## Multiroom Compatibility Firmware Update Release Notes

### **Mu-so & Mu-so Qb (v. 1.6)**

### **Classic Uniti Range, Network Players and Streaming Preamplifiers (v. 4.6)**

### **New Uniti Range (v. 2.6)**

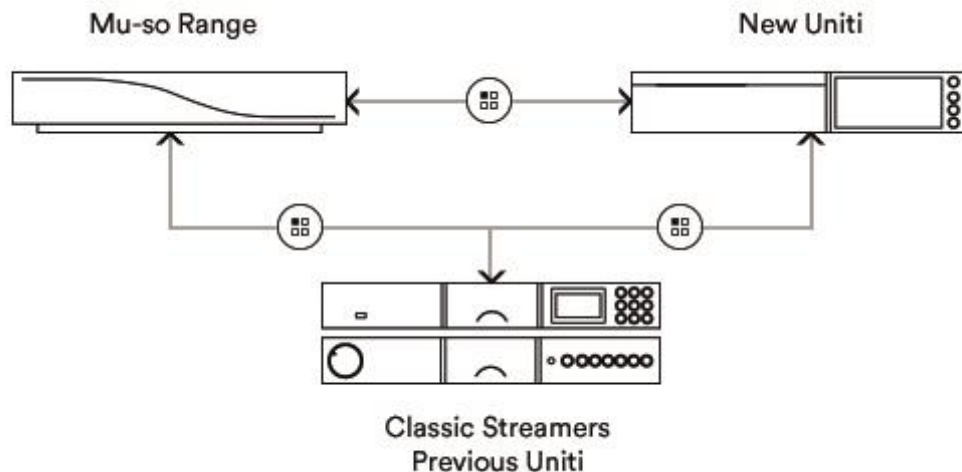
- Introduces numerous improvements to the multiroom picker interface to support the products and improve usability
- Improves the robustness of joining a multiroom group
- Improves the experience of the Mu-so and Mu-so Qb firmware update process
- Introduces the use of album artwork in situations where there is no artist artwork available
- Fixes an issue where CD input was incorrectly available to be disabled
- Fixes an issue where NAS shares were not selectable when configuring a backup
- Fixes an issue where shuffle and repeat may be displayed on inputs that don't support them
- Fixes an issue where max volume and balance may be missing from input settings
- Fixes an issue where the date may be incorrectly displayed for a firmware update
